Statement for the registration for examination of the project NPP Wylfa Newydd/UK

Introduction

Horizon Nuclear Power is proposing to construct and operate a new nuclear power plant (NPP) at the Wylfa Newydd site in Wales at the coast on the Island of Anglesey. The new NPP shall comprise two UK Advanced Boiling Water Reactors (ABWR). The site already hosts two Magnox NPPs that were shut-down in 2012 and 2015.

Wylfa-1

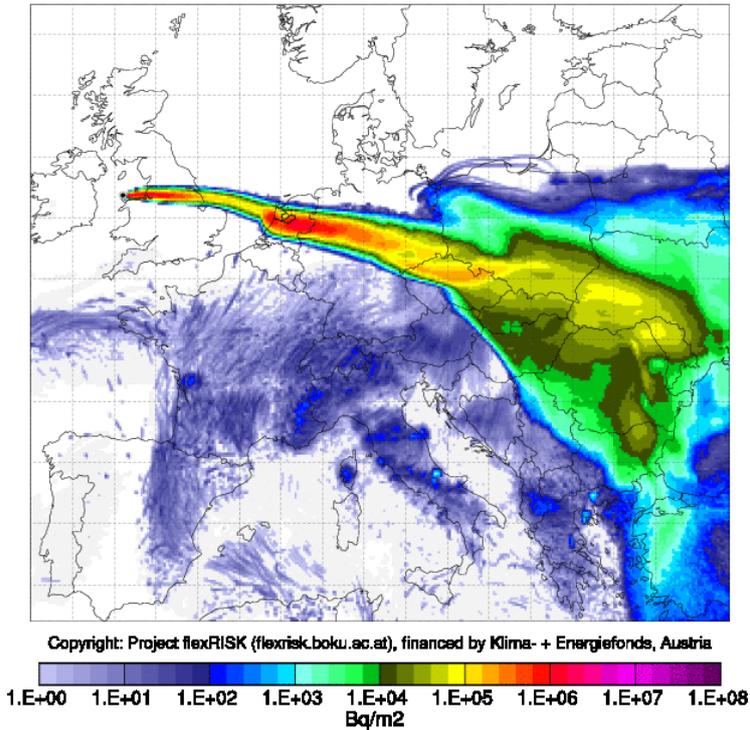
Parts of the Bulgarian territory could be contaminated with up to 50 kBq Cs-137/m² (the olive scale). This could be similar to the contamination after Chernobyl when the average contamination¹⁵ in the south of Bulgaria was about 12 kBq/m².

In case of a severe accident in Wylfa with a containment failure, whole of Europe could be contaminated severely.

Request: Any new NPP in UK needs to prove that a severe accident with a containment failure is not possible!
